TOWN GRAY
PLANNING BOARD
AGENDA • APRIL 8, 2021

a. Stillwater Pines Open Space Subdivision

A request by Birch Point Properties, LLC & A.H. Grover, Inc. for Preliminary Plan Review for Phase I of a proposed subdivision (Stillwater Pines) consisting of 13 open space subdivision lots on 68 +/- acres on an extension of Woodcock Drive off Yarmouth Road as shown on Tax Map 44, Lot 32-11. The subject parcel is in a Town Council adopted Contract Zoning Agreement, formerly in a Medium Density Zoning District.

| COVER | SHEET SET COVER |
|-------|---|
| C-101 | SUBDIVISION LAYOUT AND UTILITIES PLAN |

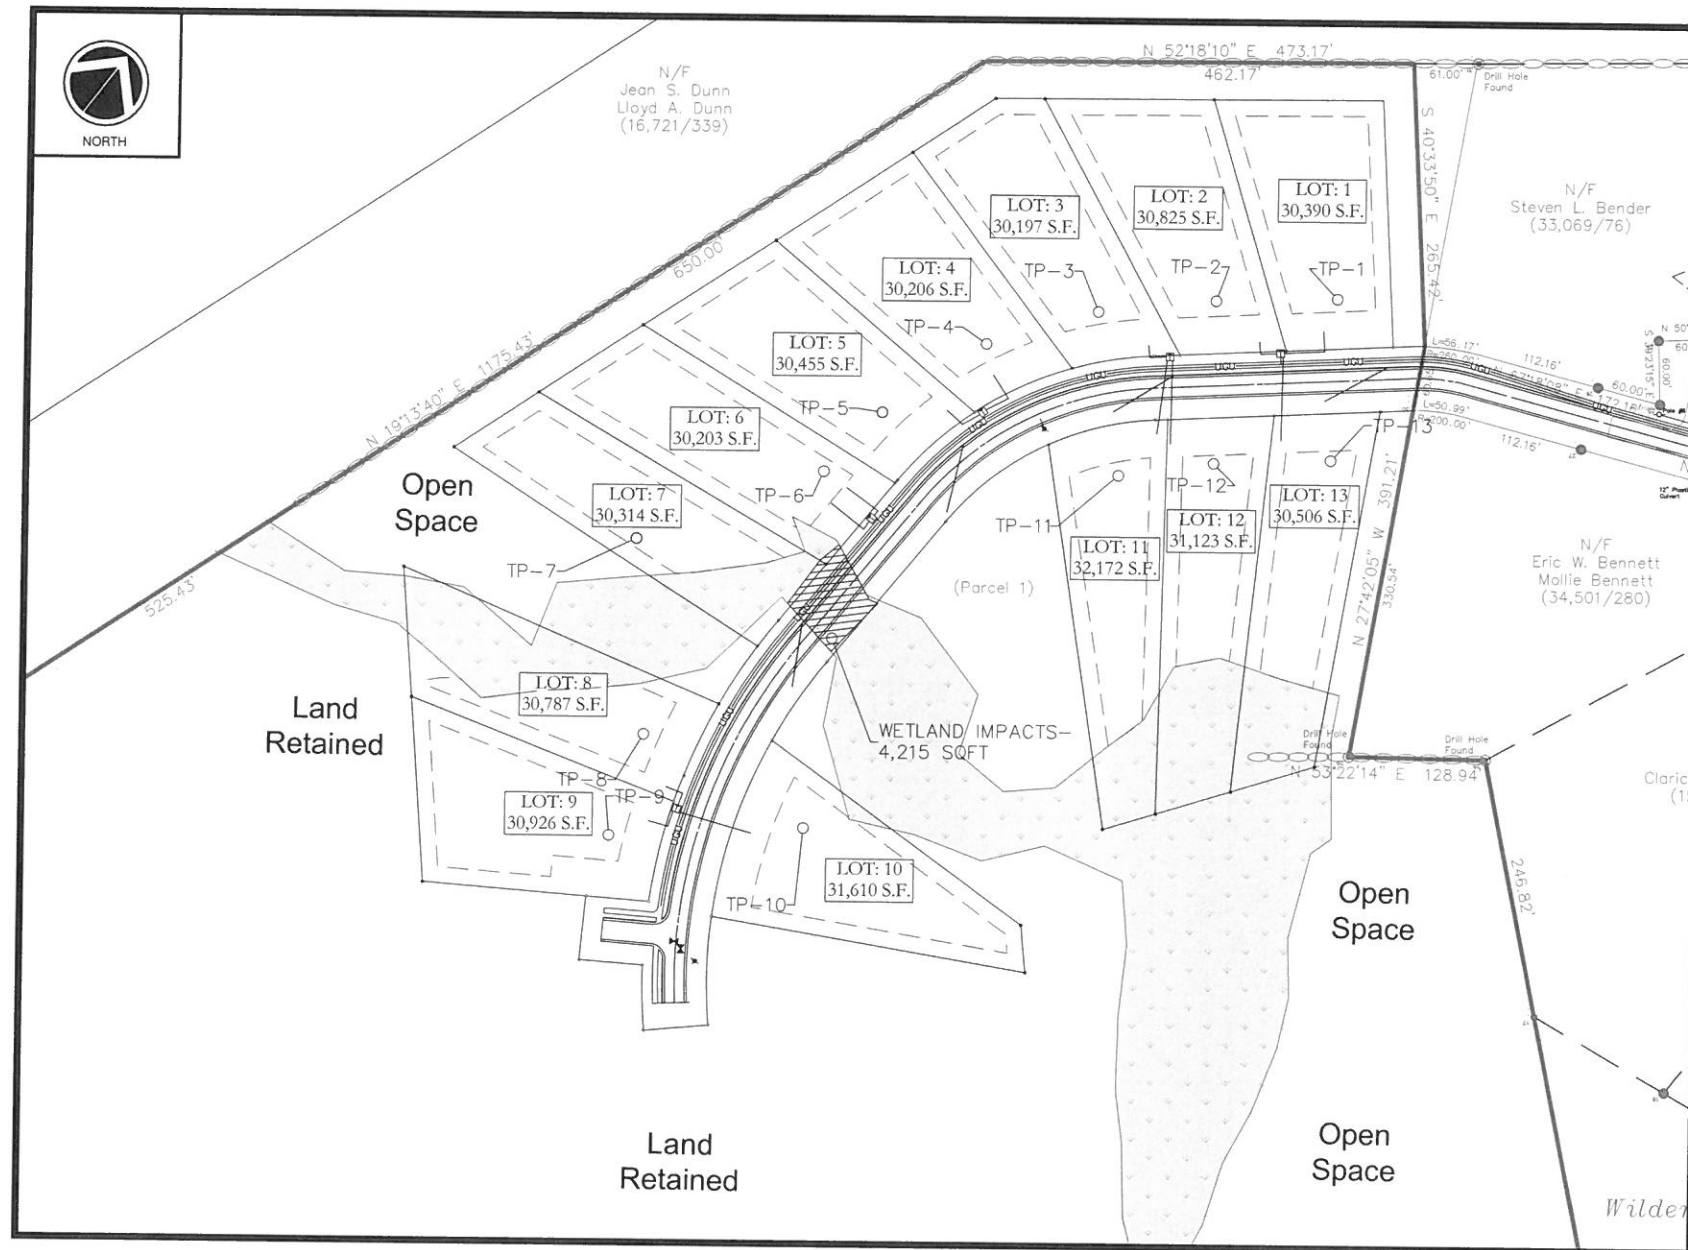
5. *Show subsurface disposal system test pits on the plans.*

6. *Revise building envelopes to exclude wetland areas.*

8. *Delineate the proposed wetland impact areas and square footages on the plans.*

- 10. Add a note for anticipated lot driveway culvert sizes. Minimum driveway culvert size shall be 15" as required by the Ordinance. Calculations should be provided to determine if larger driveway culverts are needed at any lot driveway.

Test Pits have been added to the Subdivision Layout and Utilities Plan (C-101).

Building Envelopes have been updated on the Subdivision Layout and Utilities Plan (C-101).

Wetland impacts have been added to Subdivision Layout and Utilities Plan (C-101).

A note dictating that a 15" culvert will be installed at each driveway has been added to the C-101 drawing. The areas draining to each ditch are minimal as the site is running along a ridge. The 15" culvert will be sufficient for each lot.

PLAN VIEW: UNDERDRAINED SOIL FILTER BASIN UDSF-1
SCALE 1" = 20'

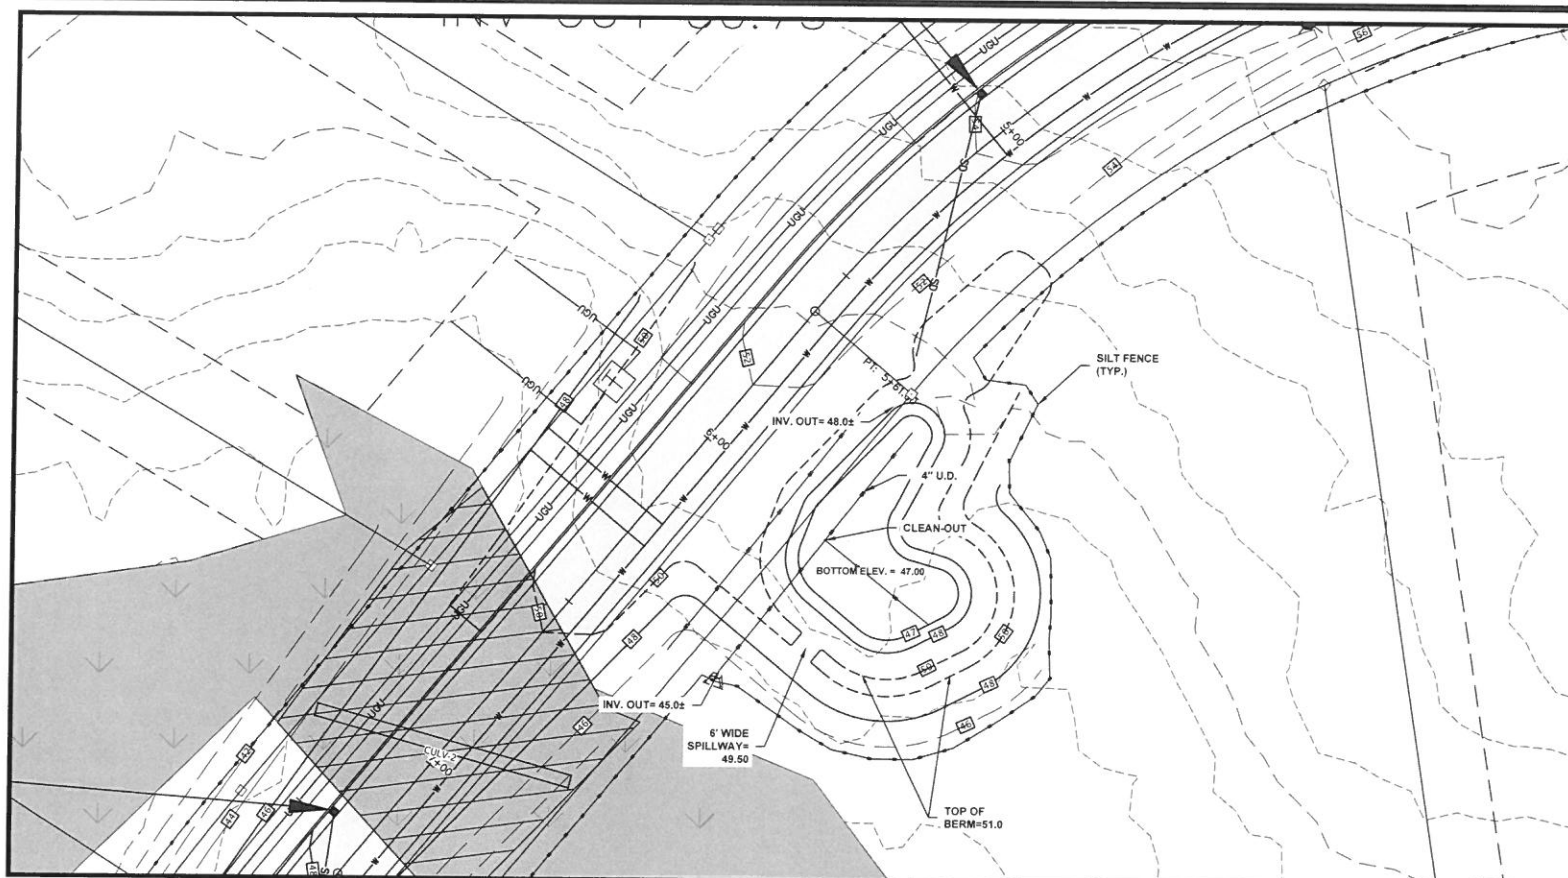
- f. *Revise the grading at UDSF 2 to tie in all existing contours.*

- h. *Provide a spec and gradation for the underdrain gravel.*

- i. *Provide a planting spec for the filter surface.*

- k. Provide an outlet apron at the underdrain outlets.

- q. UDSFs appear to be lined. Maine DEP requires test pits at UDSF locations to identify the seasonal high water/bedrock elevation. We recommend test pits as required by Maine DEP. Also, underdrains may be needed below the UDSF liners to prevent the filters from "floating". Provide floatation calculations to show that lined UDSFs will not float without the additional underdrains, unless test pits show the SHWT is below the bottom of the liners.

The notes have been updated on the UDSF detail to include the specs and gradation.

The notes have been updated on the UDSF detail to planting specs.

An outlet apron has been added to both underdrain outlet details.

A 4" perforated underdrain has been added to the side of the UDSF to prevent any floating.
